ADDENDUM No. 1

RFP No. 22-19

South State Street Reconstruction

SCALE	INCH
DRAWING NO.	C5.2
SHEET NO.	OF

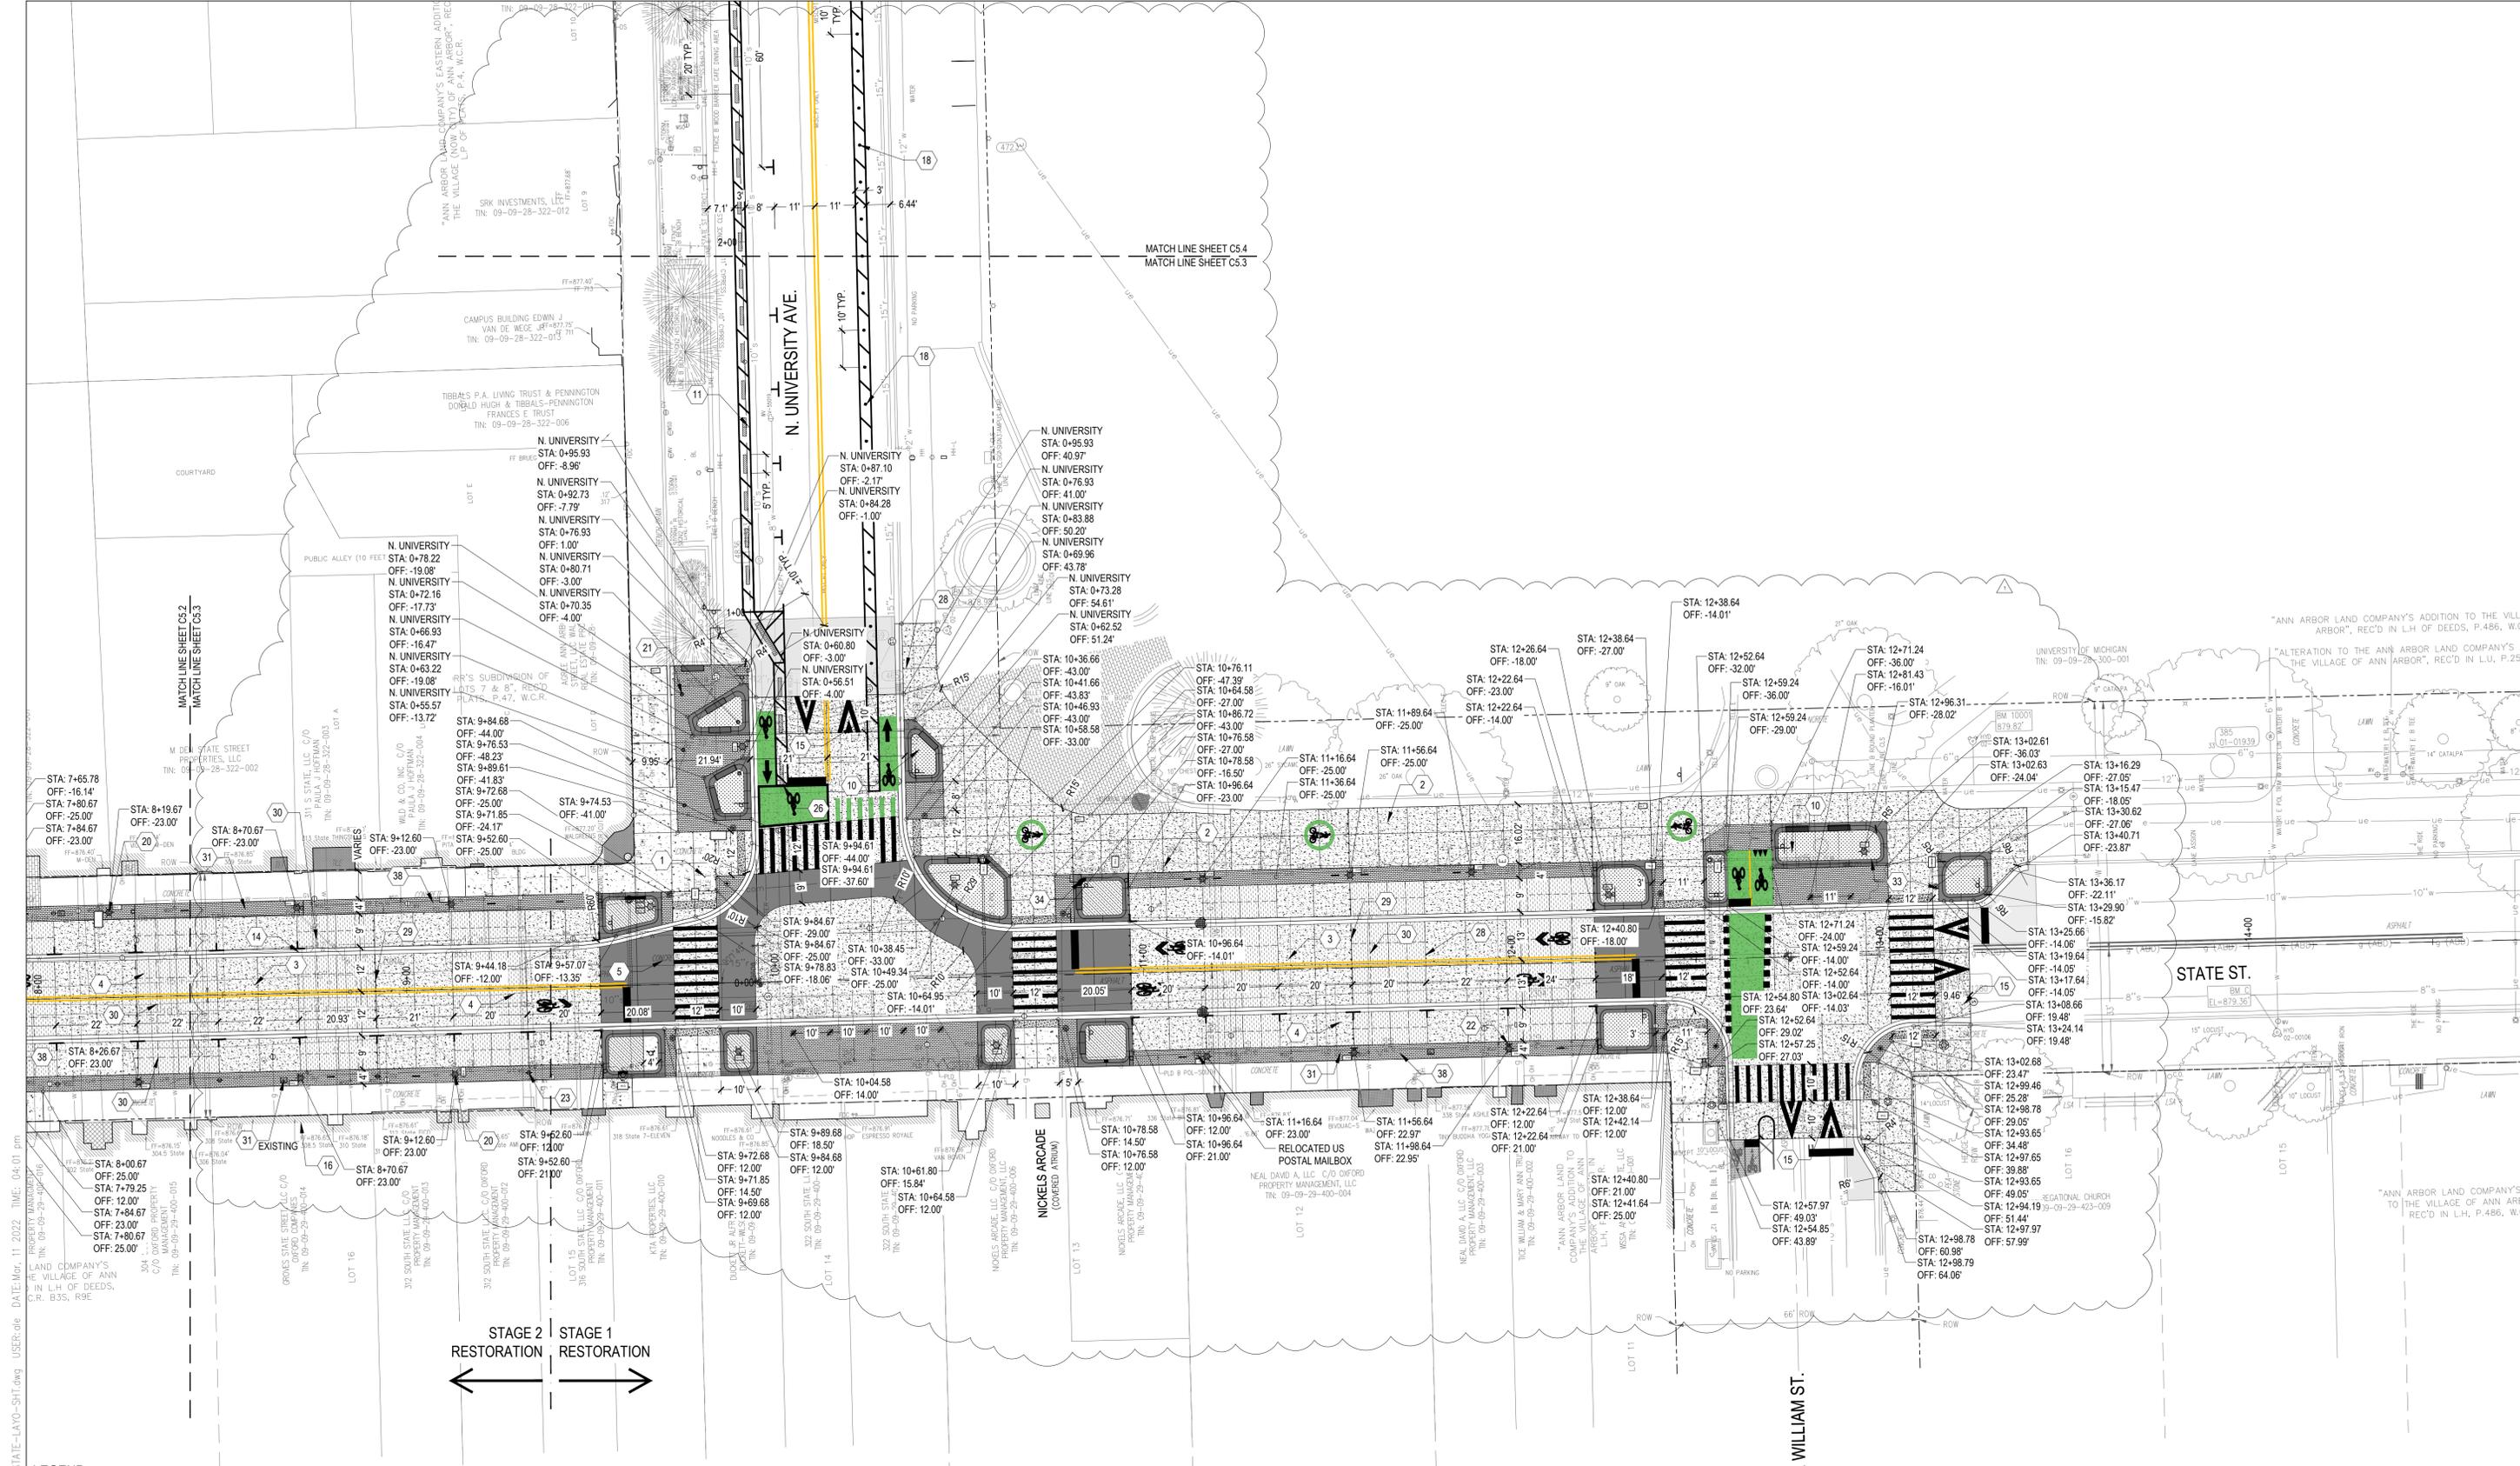
Pages 1-6 + Plans	The project is adding an APS system, as outlined on the attached drawings (C5.2, C5.3, C5.4, C8.1, C8.4, C8.5, C8.7, C8.8, and C8.9), detailed specifications, and Bid Form. The change has resulted in minor modifications to the C-5 series of drawings that are include with this addendum. The C-5 series also includes changes to the bikeway along North University.
-------------------	--

SCALE	INCH
DRAWING NO.	C11.1
SHEET NO.	OF

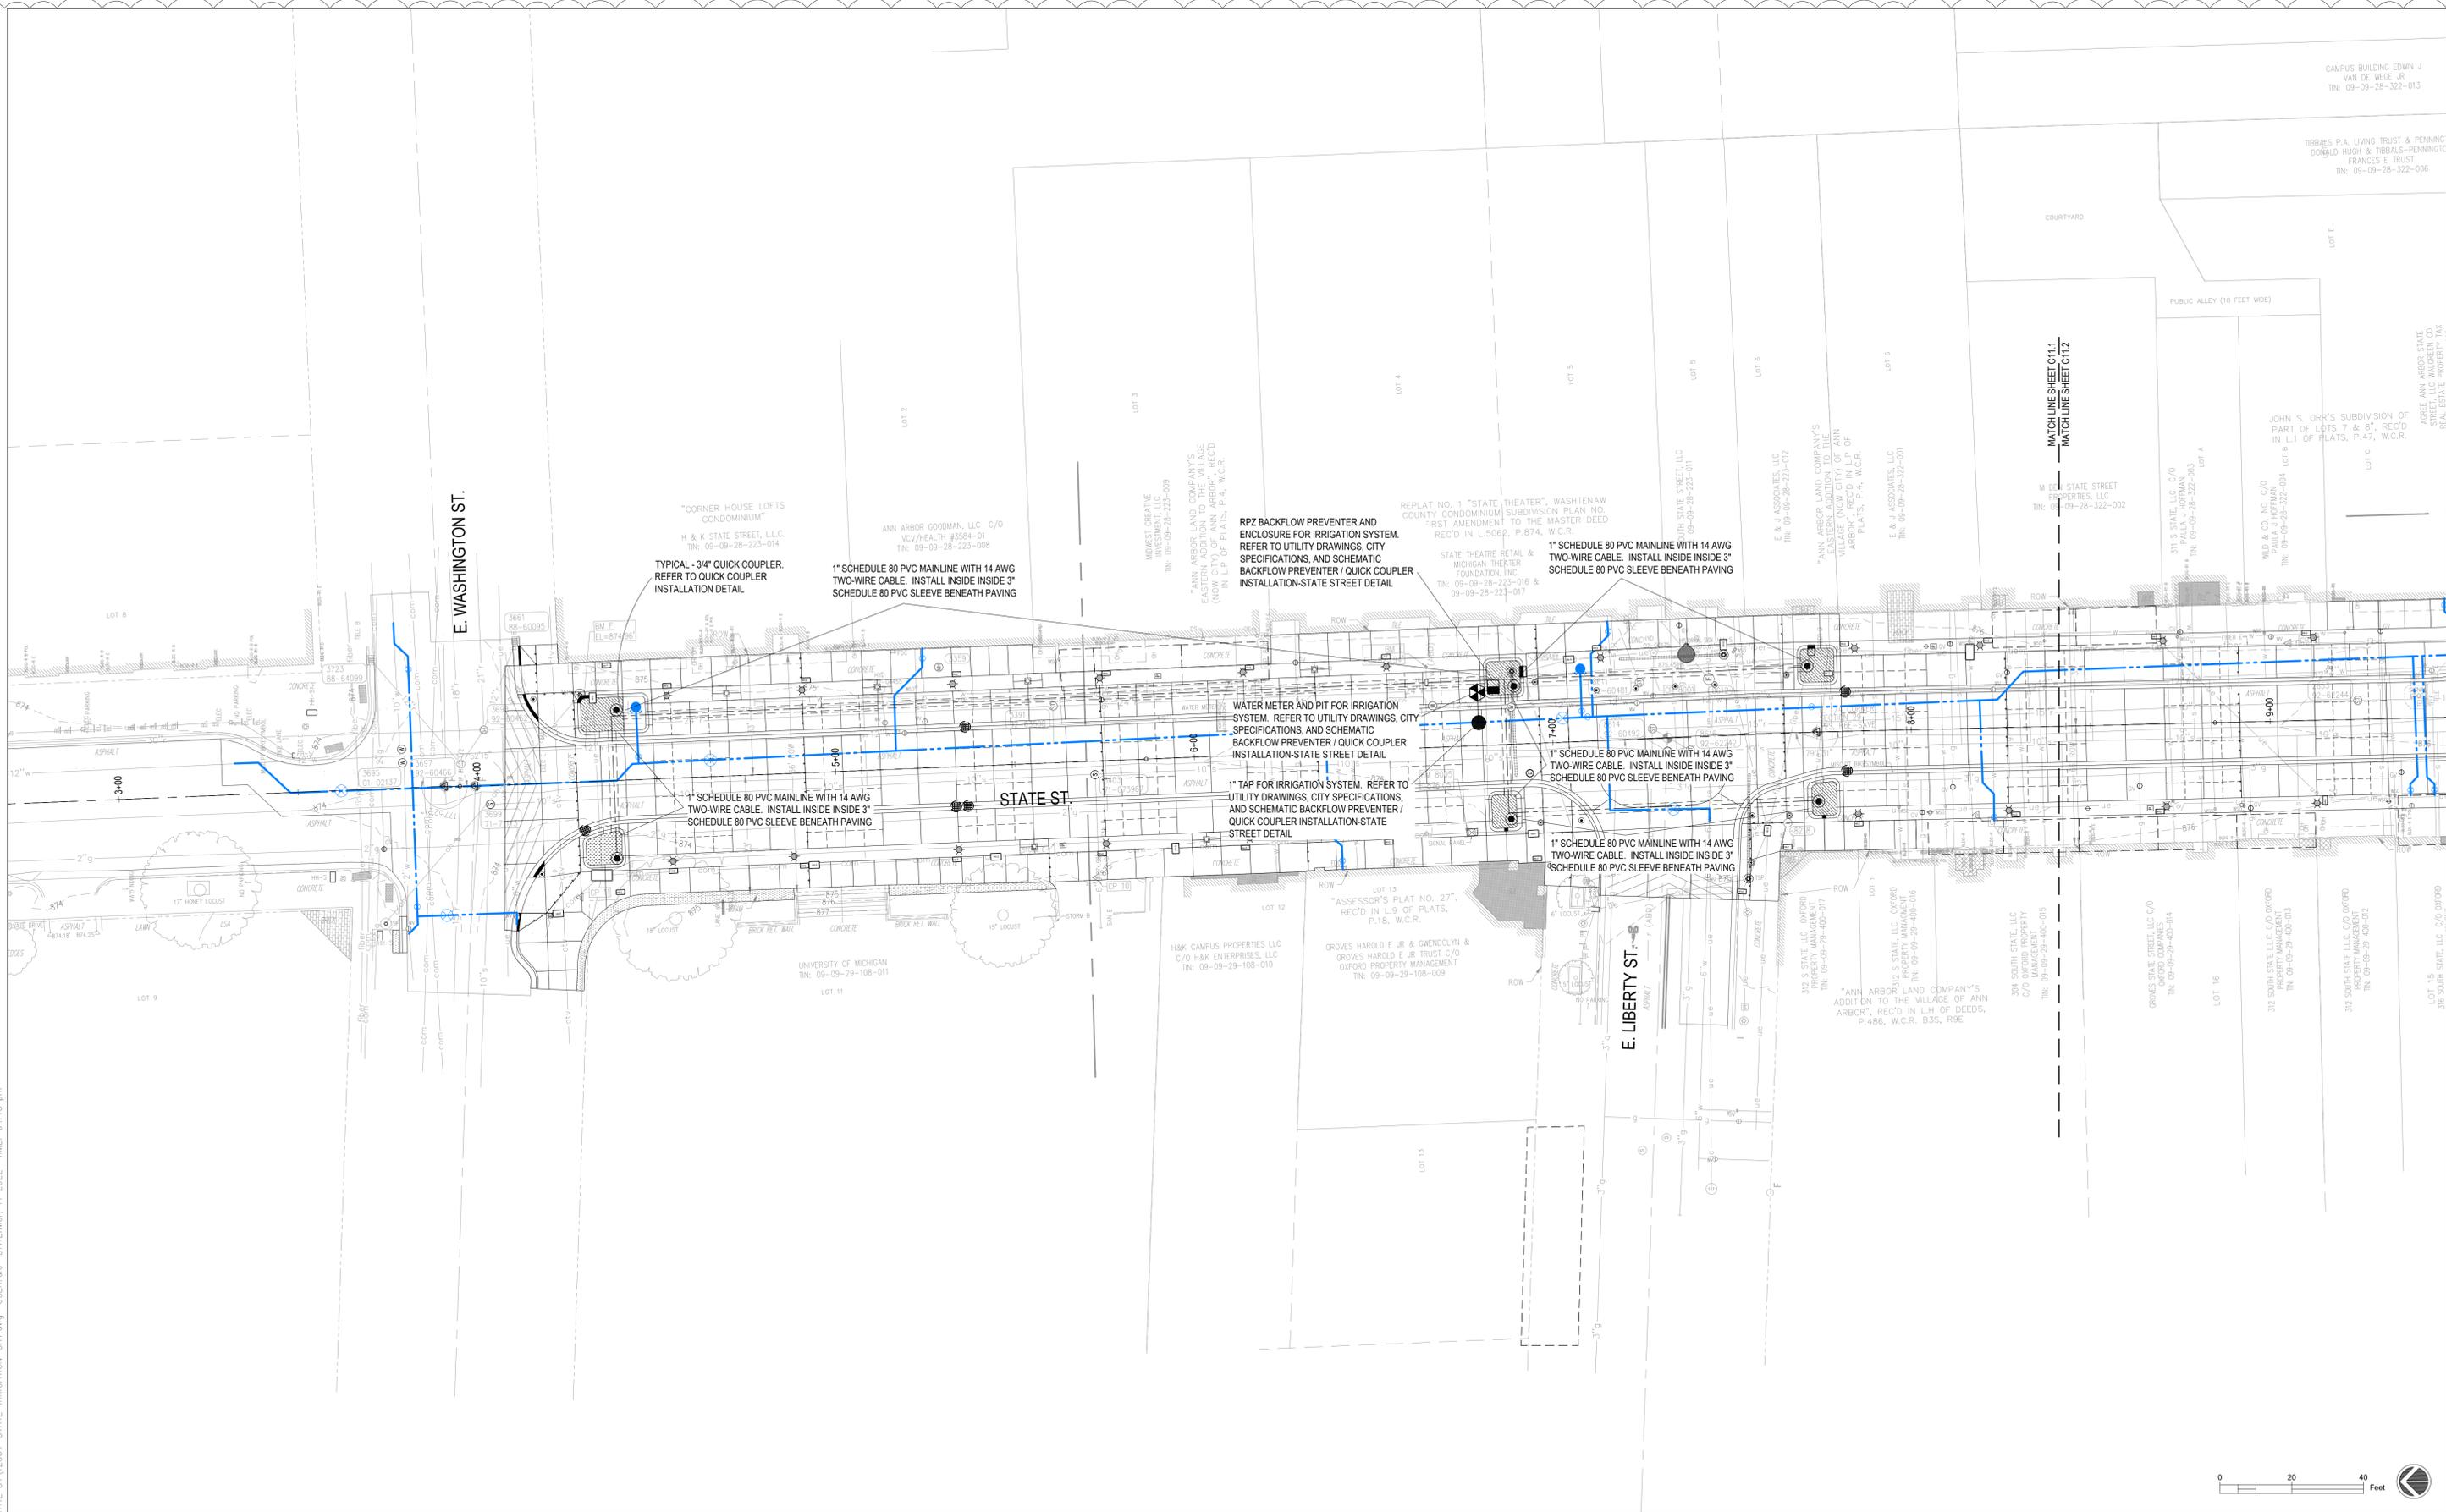
Pages 7-14 + Plans	This project is adding irrigation facilities, as outlined on the attached drawings (C11.1, C11.2, and C12.1), detailed specifications, and Bid Form.
Plans Only	The water main plans have been amended as outlined on the attached drawings, C6.2, C6.3, and C6.9.
Page 15 + Plans	The contractor is to furnish the Regulatory Street Signage to the City of Ann Arbor, as outlined on the attached drawings (C10.1, C10.2, C10.3, and C10.4), detailed specifications, and Bid Form. The City of Ann Arbor will install the signs with their own forces.
Pages 16-18 +Plans	<p>The material for pavement symbols has been changed from “OVLY, COLD PLASTIC” to “POLYUREA” for the following pay items-</p> <p>Item 259-03: Pavt Mrkg, Polyurea, Bike Arrow and Yield Sym. Item 259-04: Pavt Mrkg, Polyurea, Special Sym. Item 259-05: Pavt Mrkg, Polyurea, Bike Sym. Item 259-06: Pavt Mrkg, Polyurea, Sharrow Sym.</p> <p>This change is reflected on the attached plans (C10.1, C10.2, C10.3, and C10.4), detailed specifications, and Bid Form.</p>
